UNITED STATES PATENT AND TRADEMARK OFFICE

APPLICATION NO.	FILING DATE	FIRST NAMED INVENTOR	ATTORNEY DOCKET NO.	CONFIRMATION NO.
10/701,698	11/05/2003	Ricardo Blank	8496-US	7089
74476	7590	09/15/2010		
Nestle HealthCare Nutrition			EXAMINER	
12 Vreeland Road, 2nd Floor, Box 697			MARCETICH, ADAM M	
Florham Park, NJ 07932			ART UNIT	PAPER NUMBER
			3761	
NOTIFICATION DATE	DELIVERY MODE			
09/15/2010	ELECTRONIC

Office Action Summary	Application No. 10/701,698	Applicant(s) BLANK ET AL.
	Examiner ADAM MARCETICH	Art Unit 3761

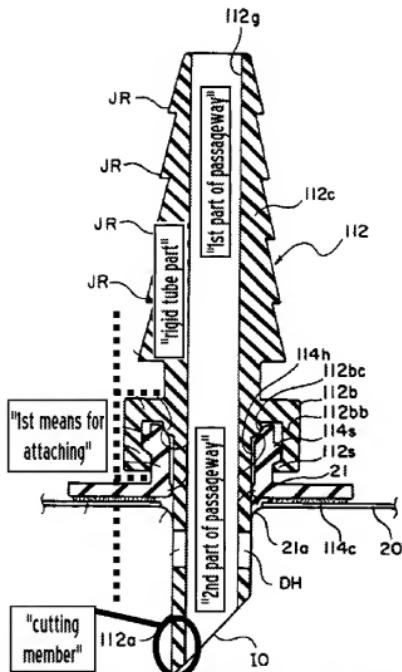
the cutting member protruding from an interior of the first means (annotated Fig. 6, pointed end 112a protrudes

downwards from within the inner perimeter of annular rim 112b).

16. Regarding claim 3, Kawaguchi discloses a cutting member protruding from the connector device in a direction towards the laminated paper packaging system for cutting the laminated paper packaging system upon screwing the connector device onto the laminated paper packaging system (¶ [0049], [0051], annotated Fig. 6, pointed end 112a).
